UNITED STATES PATENT AND TRADEMARK OFFICE

APPLICATION NO.	FILING DATE	FIRST NAMED INVENTOR	ATTORNEY DOCKET NO.	CONFIRMATION NO.
10/526,452	03/02/2005	Andreas Zahnd	71190	3135

Office Action Summary	Application No.	Applicant(s)	
	10/526,452	ZAHND ET AL.	
	Examiner	Art Unit	
	Leslie J. Evanisko	2854

DETAILED ACTION

3,362,327

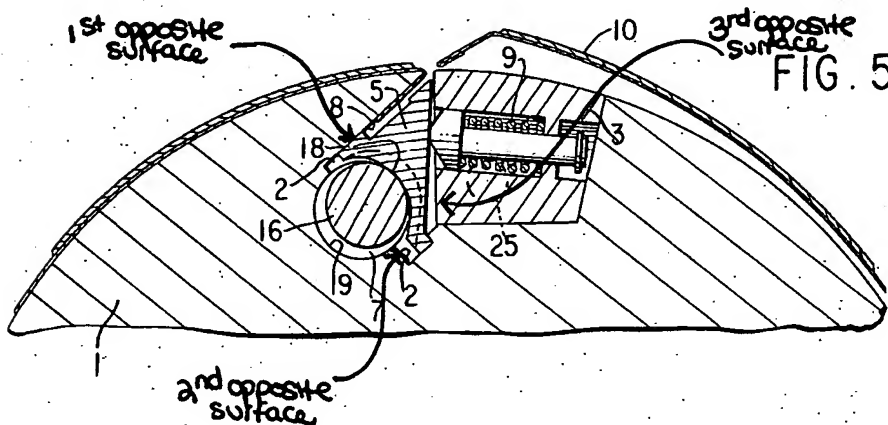
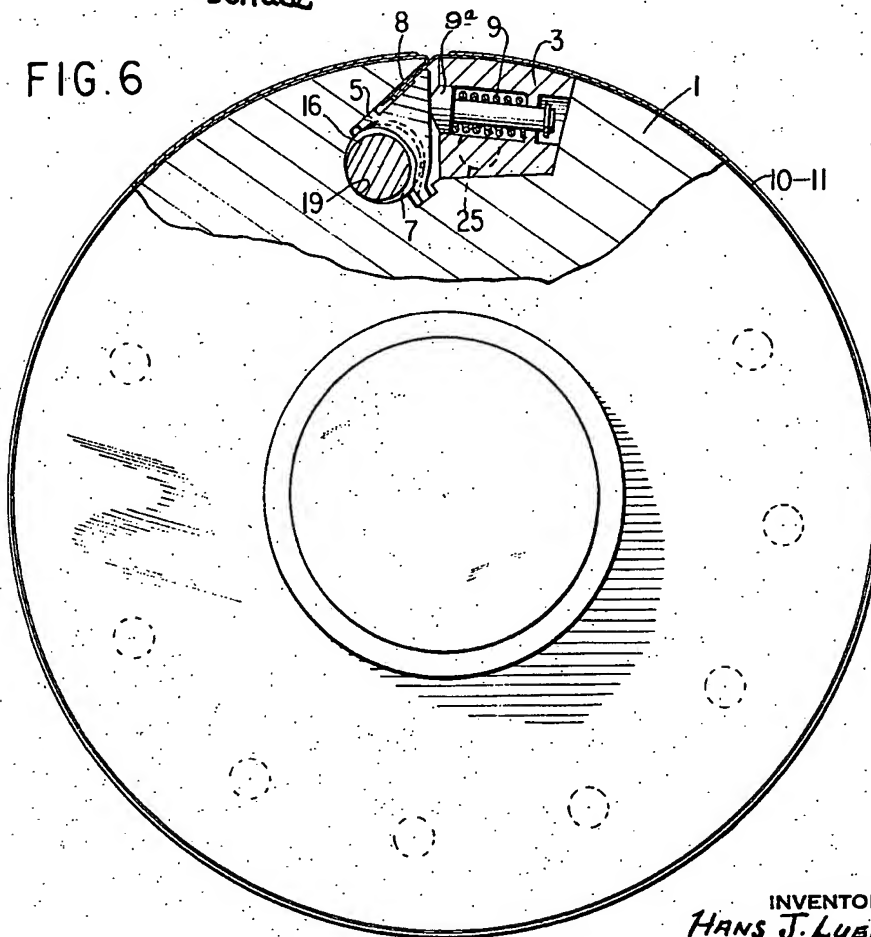
10. Claims 1-3, 15-16, and 28 are rejected under 35 U.S.C. 102(b) as being anticipated by Luehrs (US 3,362,327). Luehrs teaches a clamping device for clamping a flexible packing 10, 11 of a cylinder 1 of a printing press, which cylinder has an axial channel 2 on a jacket surface, the clamping device comprising a clamping body 4, 5, 6, 7, which forms a clamping gap in the axial channel 2 with a first opposite surface (defined by wall 8) for at least one end of the packing 10, 11, which end protrudes through the opening of

the axial channel 2; two channel walls (as illustrated in marked-up copy of Figure 5 attached to this Office Action) which face the first opposite surface, and which form the second opposite surface and third opposite surface, on which the clamping body 4, 5, 6, 7 is supported, touching the opposite surfaces; wherein at least one of the clamping body 4, 5, 6, 7 and opposite surfaces form a spring and the force of elasticity of the spring tensions the clamping body and the first opposite surface towards each other in order to clamp the at least one end of the packing 10, 11 with the packing pulled in. See, in particular, Figures 1b and 3-6 and the marked-up copy of Figure 5 attached to this Office Action.

With respect to claim 3, note the opposite surfaces of Luehrs form support points for the clamping body which are distributed around the circumference of the clamping body, wherein two adjacent support points each have an angular distance of less than 180°, as shown in Figures 5 and 6 in particular.

2,900,904

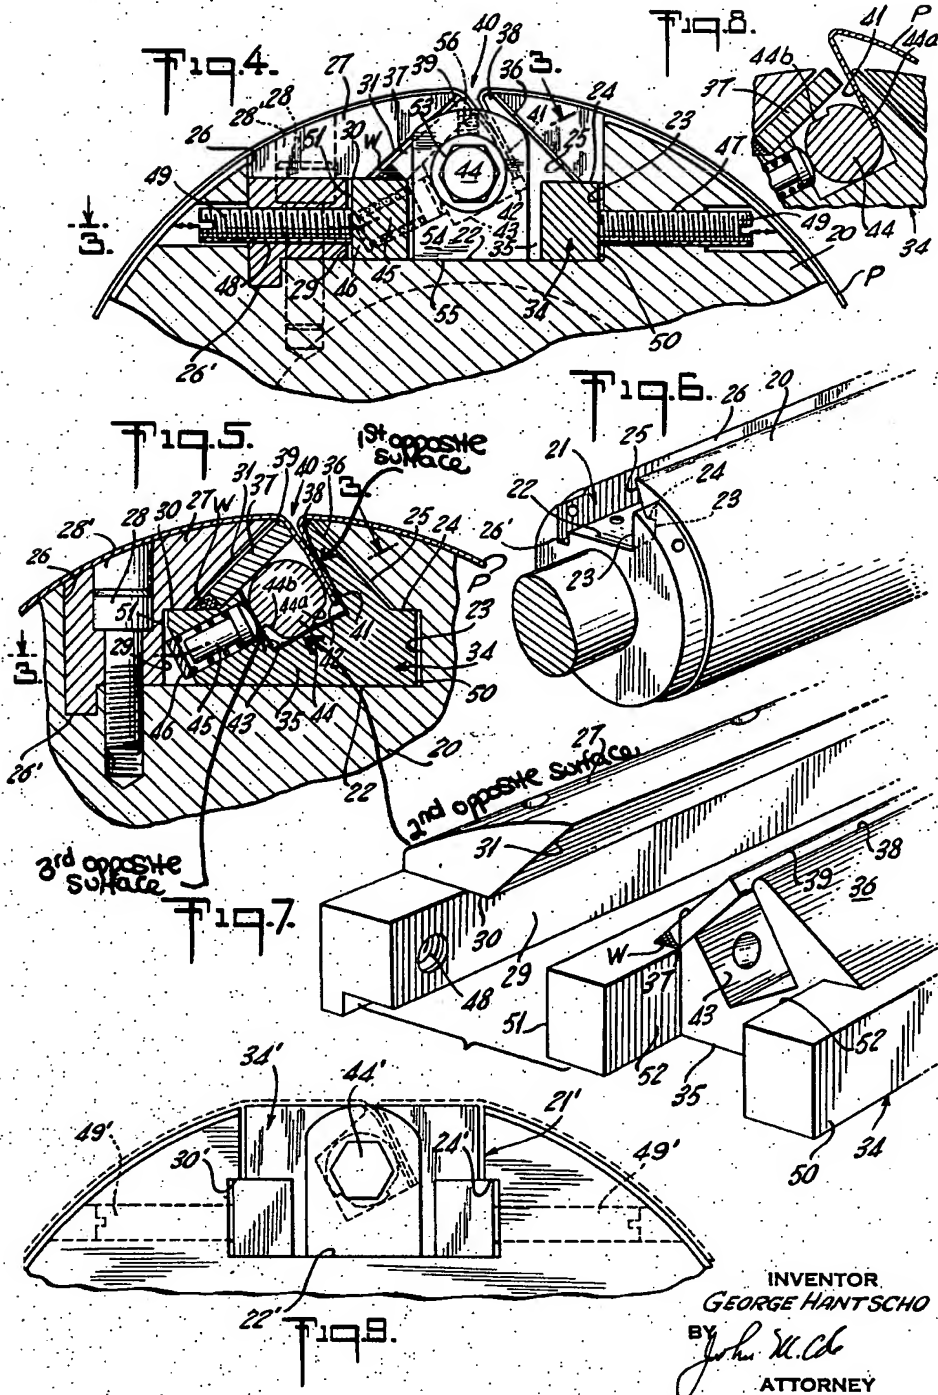
9. Claims 1-3, 15-16, 20, and 27 are rejected under 35 U.S.C. 102(b) as being anticipated by Hantscho (US 2,900,904). Hantscho teaches a clamping device for clamping a flexible packing P of a cylinder 20 of a printing press, which cylinder has an axial channel 43 on a jacket surface, the clamping device comprising a clamping body 44 which forms a clamping gap in the axial channel with a first opposite surface (face defined by edge 38) for at least one end 41, 42 of the packing P, which end protrudes through the opening 40 of the axial channel 43; two channel walls (as illustrated in marked-up copy of Figure 5 attached to this Office Action) which face the first opposite surface, and which form the second opposite surface and third opposite surface, on which the clamping body 44 is supported, touching the opposite surfaces; wherein at least one of the clamping body 44 and opposite surfaces form a spring and the force of elasticity of the spring tensions the clamping body and the first opposite surface towards each other in order to clamp the at least one end 41, 42 of the packing P with the packing pulled in. See, in particular, Figures 4-8 and the marked-up copy of Figure 5 attached to this Office Action.

With respect to claim 3, note the opposite surfaces of Hantscho form support points for the clamping body which are distributed around the circumference of the clamping body, wherein two adjacent support points each have an angular distance of less than 180°, as shown in Figures 5 and 8 in particular.
